Executive Director's Recommendation

Commission Meeting: April 2, 2020

PROJECT Rock Creek National Park Signage Guidelines Rock Creek National Park Washington, DC	NCPC FILE NUMBER 8084 NCPC MAP FILE NUMBER 00:00(00.00)45083
SUBMITTED BY United States Department of the Interior National Park Service	APPLICANT'S REQUEST Approval of final site development plans
REVIEW AUTHORITY Federal Projects in the District per 40 U.S.C. § 8722(b)(1) and (d)	PROPOSED ACTION Approve final site development plans with comments
	ACTION ITEM TYPE Consent Calendar

Rock Creek National Park Signage Guidelines

Meridian Hill Park

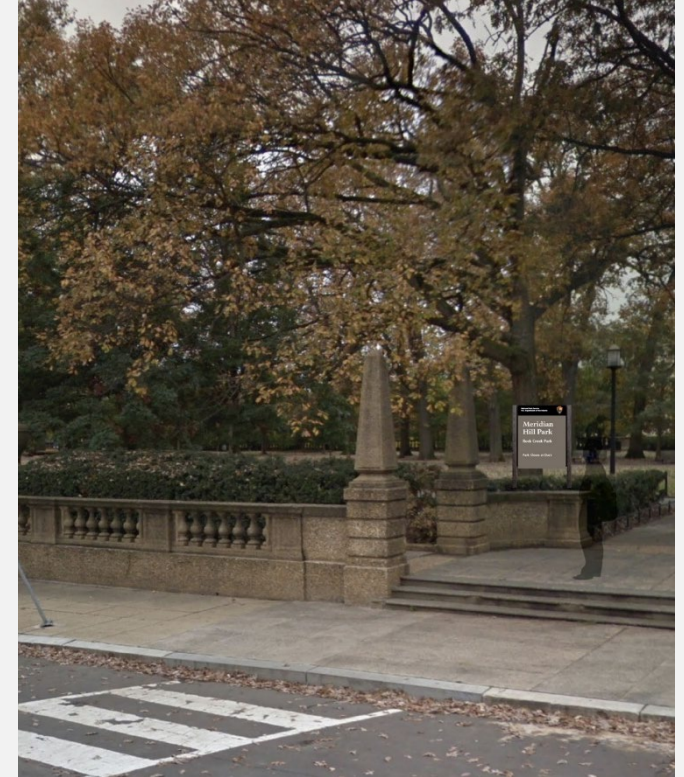
As the project advances, staff believes it will be helpful to for NPS to continue to evaluate specific installation locations for any new primary Monument ID or Pylon ID signs not included in the demonstration site visualizations or on-site mock-ups, as these have the greatest potential for any visual impacts or effects on historic resources. These also tend to be the largest signs. As such, staff recommends the Commission **recommends that NPS continue to evaluate the type and amount of signage proposed for Meridian Hill Park, and limit the use of Pylon ID signs unless constrained by lack of space for horizontal signs.** Generally, the replacement of other wayfinding or information signs are unlikely to change the character or setting of the park or impact any resources. NPS will engage staff on further details regarding signage at Meridian Hill Park as they develop.

Meridian Hill Park – Full-size Mock-up

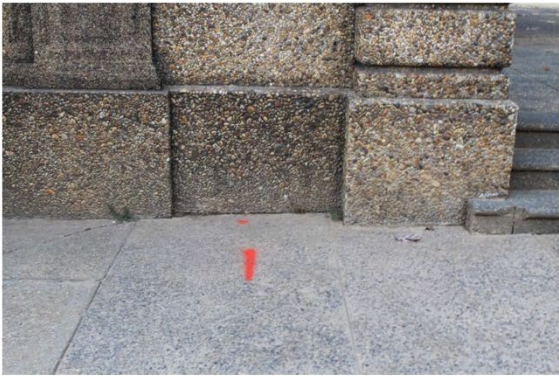
Recommends that NPS continue to evaluate the type and amount of signage proposed for Meridian Hill Park, and limit the use of Pylon ID signs unless constrained by lack of space for horizontal signs.

This sign type was subsequently determined not to be used at Meridian Hill Park, based on the mock-up study.
